RS-18-022

Dresden Nuclear Power Station, Units 2 and 3  
Renewed Facility Operating License Nos. DPR-19 and DPR-25  
NRC Docket Nos. 50-237 and 50-249

Subject: Response to NRC Request for Additional Information for Request for License Amendment to Revise Technical Specification 5.5.12, "Primary Containment Leakage Rate Testing Program"

### Response to Request for Additional Information

FIGURE 5-1: CSI RELEASE FRACTION TO THE ENVIRONMENT

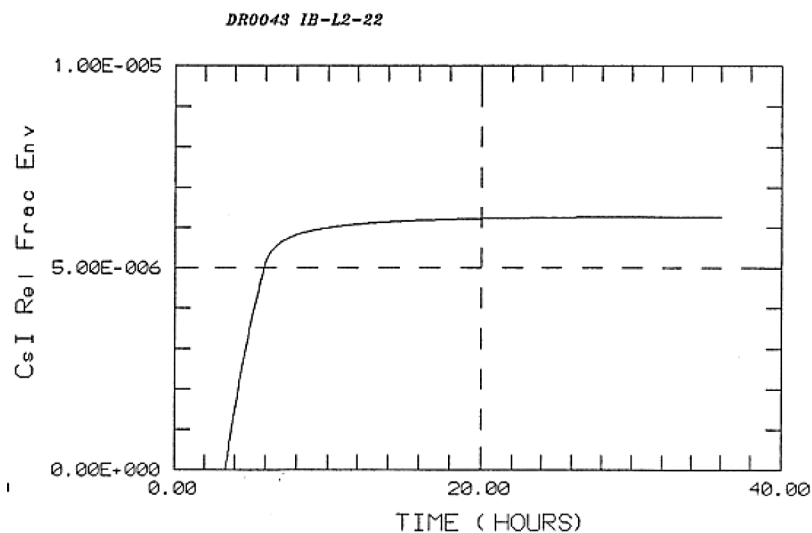
*The NRC staff requests the licensee to explain the likelihood of further releases after 36 hours, and if likely, provide an updated assessment of the releases against the population dose criteria for internal as well as external events.*

Figure 5-1 shows the cumulative release fraction released to the environment via technical specification leakage for CsI, where iodine is recognized to be a significant contributor to early dose. The release plot plateaus by approximately 12 hours. Figure 5-2 shows similar results for CsOH, where Cs is recognized to be a significant contributor to long term dose. The plot shows the rate of release decreasing substantially after 8 hours. Figure 5-3 shows the results for noble gases which are generally unaffected by water addition and therefore continue to increase in release in effectively a linear fashion. Noble gases do not significantly contribute to long term doses, which are the major constituents of the SAMA population dose results (i.e., individuals living long term on marginally contaminated land), since noble gases are non-depositing.
